# PENRITH CITY COUNCIL

## MAJOR ASSESSMENT REPORT

<b>Application number:</b>	DA21/0836
<b>Proposed development:</b>	Construction of an Attached Dual Occupancy with Strata Subdivision
<b>Property address:</b>	6 Assisi Close, CRANEBROOK NSW 2749
<b>Property description:</b>	Lot 20 DP 1197799
<b>Date received:</b>	10 November 2021
<b>Assessing officer</b>	James Heathcote
<b>Zoning:</b>	Zone R2 Low Density Residential - LEP 2010
<b>Class of building:</b>	Class 1a
<b>Recommendations:</b>	Approve

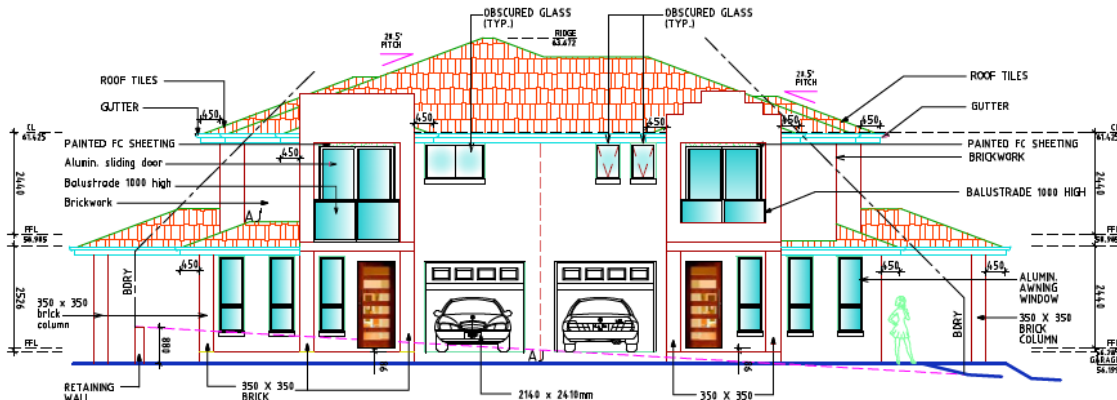
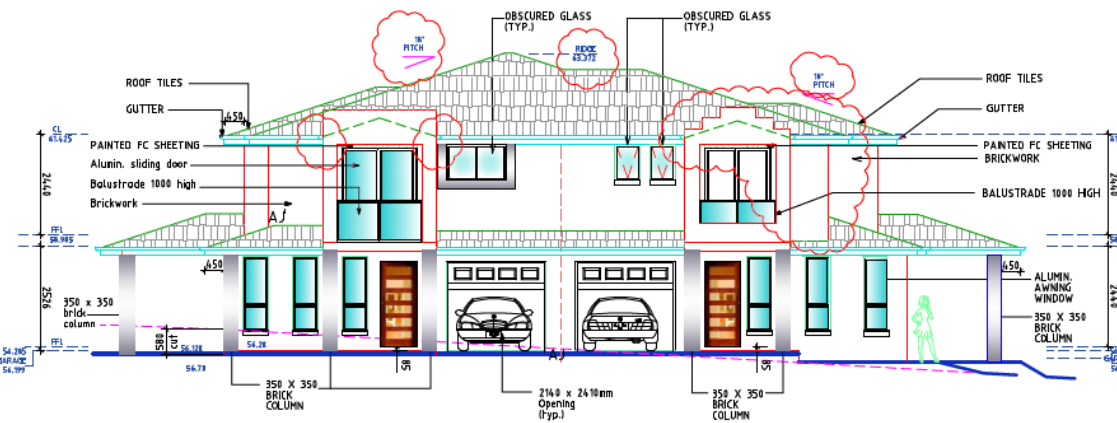
*There are design issues raised with the proposed front building elevation presentation, including blank façade sections, protruding parapets, and inconsistent use of fenestration. The proposed building also has a non-compliant building envelope, with the plans showing portions of building that are exceeding the building envelope control.*

**Response:** Please find attached amended plans that address the above requirements, specifically:

Rear Elevation	Resultant effects of the above floor and roof changes
North Elevation	Resultant effects of the above floor and roof changes
South Elevation	Resultant effects of the above floor and roof changes

Additional Porch line envelope and Building line envelope plans have been added to the architectural plan set to demonstrate compliance with the prescribed building envelope.

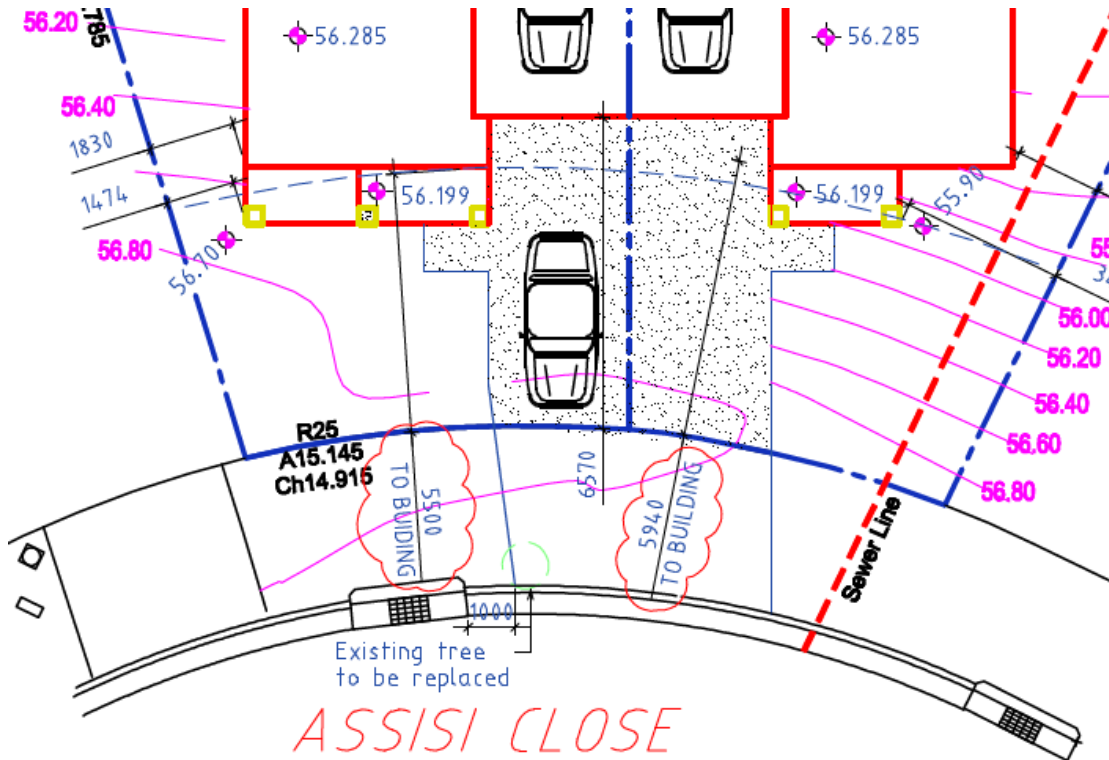
*The proposal includes a range of 4.7m to 5.46m front setbacks proposed for the front building line for the dual occupancy.*

*Average setbacks along Assisi Close have an approximate average of 5-8m front setbacks along Assisi Close.*

A minimum front 5.5m front setback for the proposed building is required.

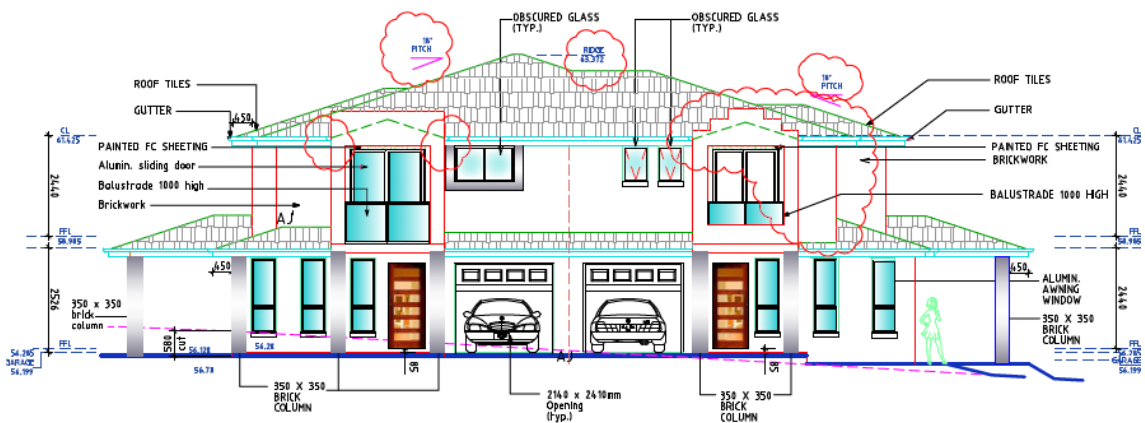
1) *Development is to comply with the building envelope for the site. The building envelope means a height plane over the site at 45 degrees from a specified height above natural ground level at the side boundaries of the site, as shown in Figure D2.5.*
